SERVICE LETTER 217

Cessna 208 & 208B Exhaust Duct & Engine Cowling Repair

Aircraft Makes/Model(s):	Float Model(s):	Compliance: Mandatory	By: MAB
Textron Aviation 208 & 208B	8750	Part Number: 1011606	Approved: SDW
		Date: 7/21/2021	Revision: C

Figure 1 Lower Right Cowl - Exterior

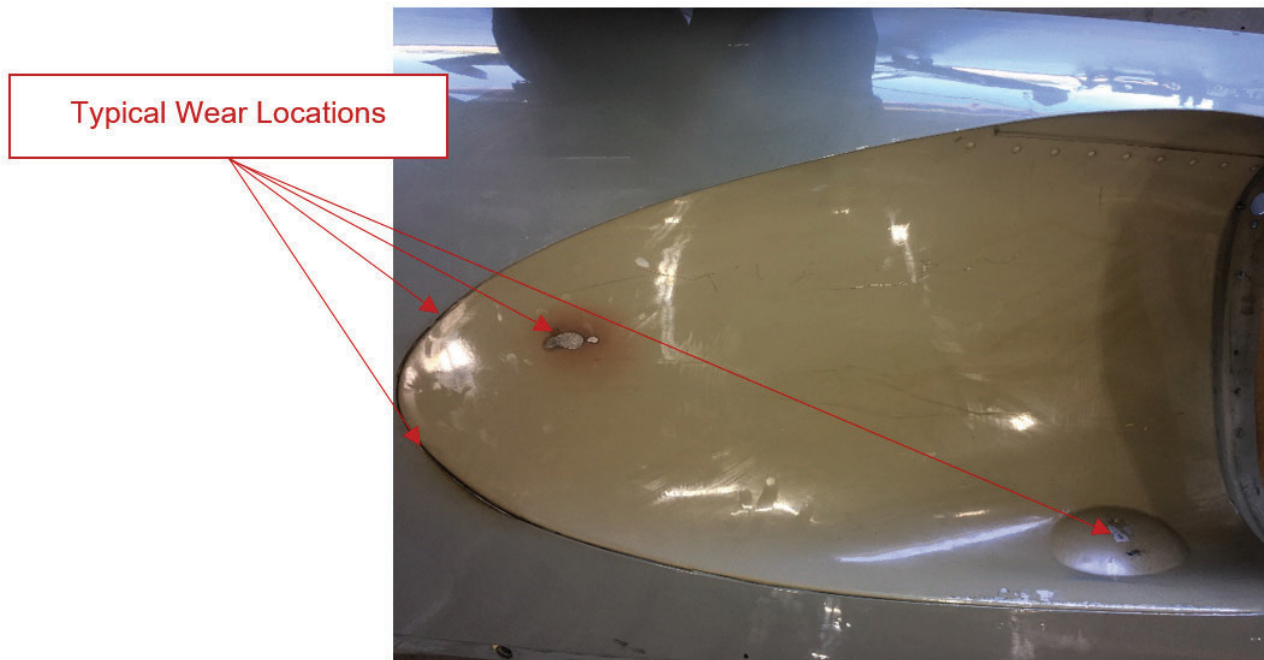
1. Using a flashlight visually inspect cowling and exhaust for wear; areas of reduced clearance are shown in Figure 1.

Figure 2 - Lower Right Cowl - Interior

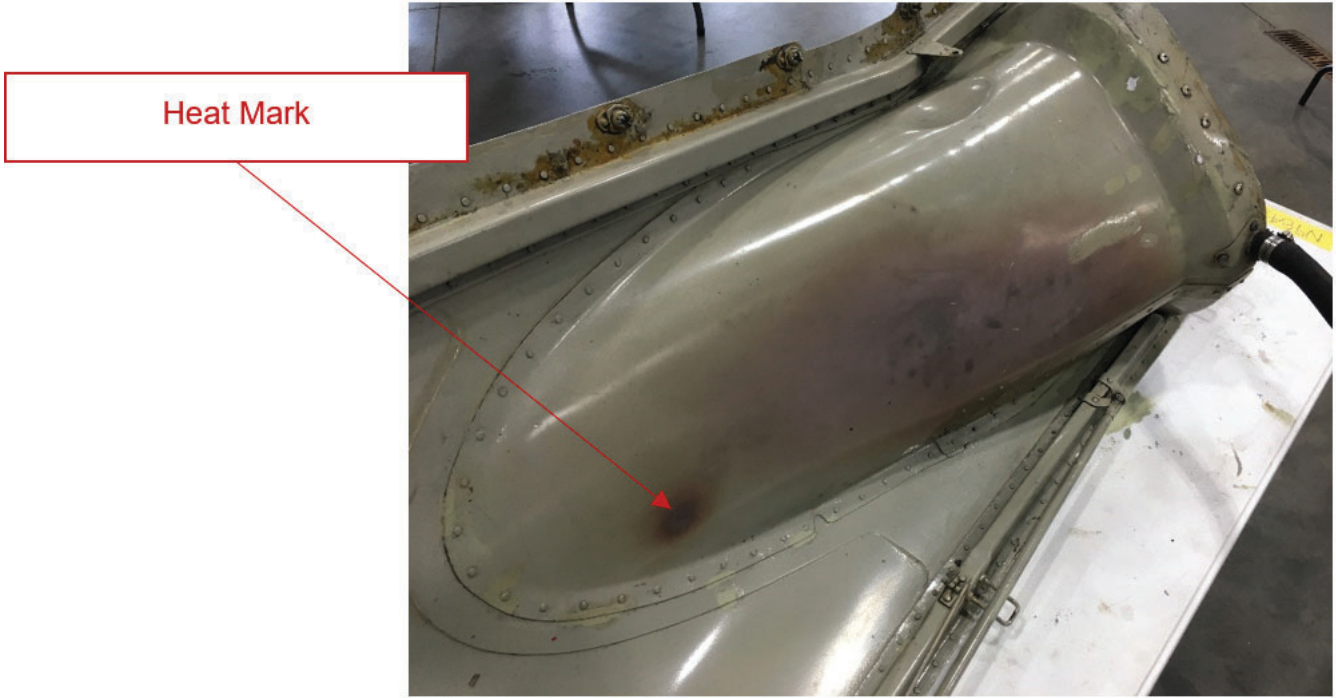
2. Inspect exhaust and cowling to determine existing clearance. The desired exhaust to cowling clearance is .25 inches. The desired fly-wire to exhaust clearance is 0.31 inches.
3. Open right hand cowl door; inspect inner cowl panel for heat marks as shown in Figure 2.

Figure 4 - Heatshield Area

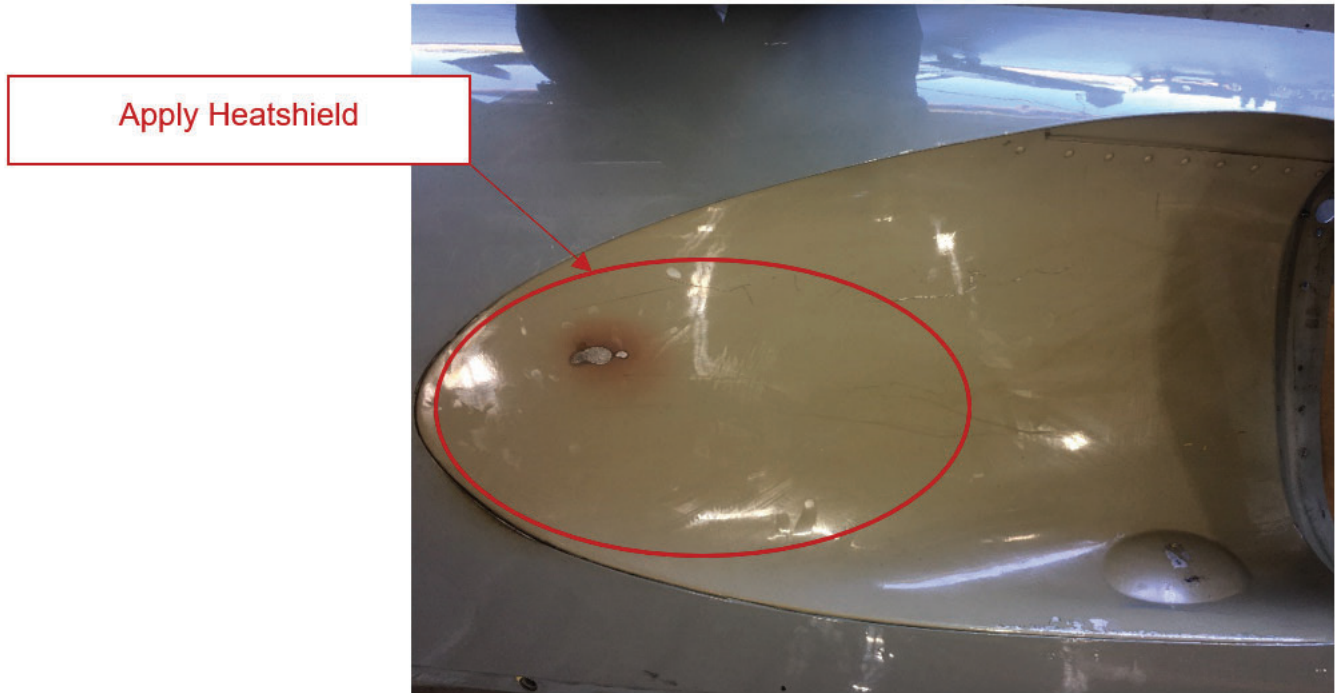
1. Remove lower right cowl per Cessna AMM.
2. Remove oil breather attach neck from cowl (3 bolts).
3. Remove secondary exhaust from cowl (8 screws).
4. Observe any areas of wear. Trim the cowling skin to match the inner panel from the rear of the cowling to a point 36.0 inches forward as needed for clearance (blend smoothly with forward opening); the skin may also be chamfered.
5. Clean exterior surface of inner cowl panel.
6. Apply epoxy primer to areas of bare aluminum.
7. Apply 1011605 self-adhesive heatshield to exterior of cowling (aft portion of inner cowl panel).

Figure 5 - Exhaust Hanger Brackets

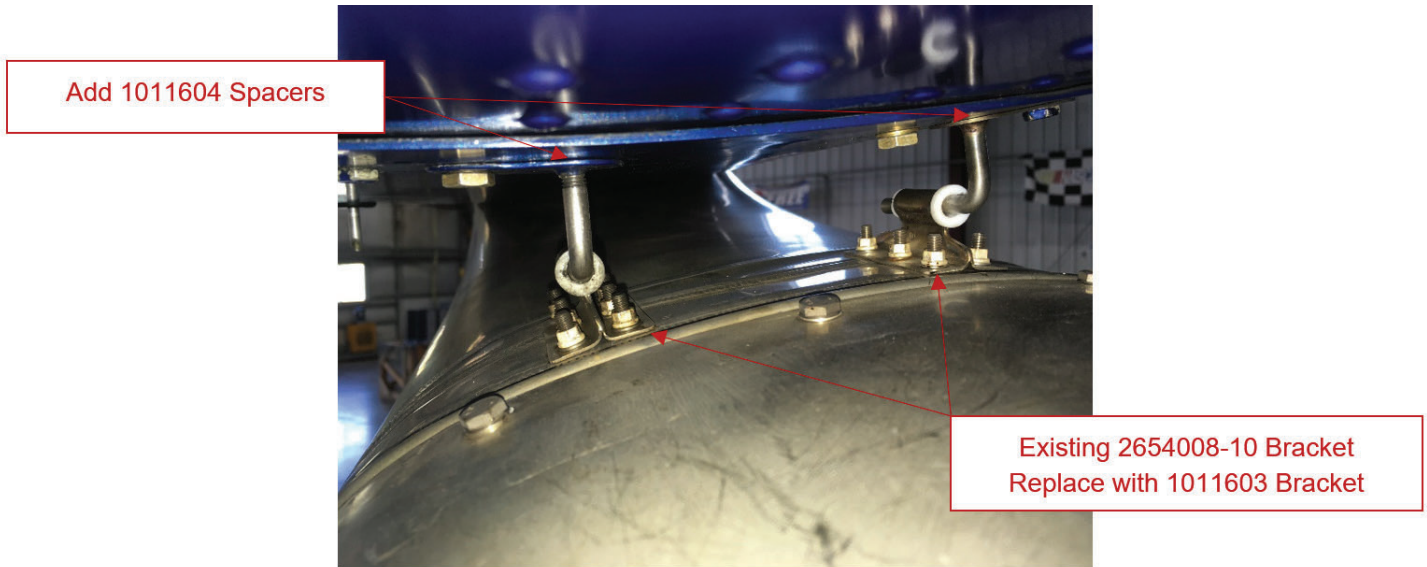
NOTE: 1011604 spacers may also be installed (up to six at each hanger). The spacers will reduce fly-wire clearance (0.31 inches should be maintained). To install spacers: remove hanger, place spacer between hanger and cowl, install with original hardware (a longer MS35207 screw may be required).

10. Remove 2654008-10 brackets from secondary exhaust (12 bolts).
 11. Remove 2654008-14 bushings from 2654008-10 bracket and install bushings in replacement 1011603 brackets.

12. Position 1011603 brackets on exhaust hangers.
- NOTE:** Position exhaust bracket with short leg aft.
13. Position 1011603 brackets (12 bolts) with secondary exhaust (bolts should be loose enough to allow bracket to move in relation to the exhaust; the bolts will be tightened in step 20).
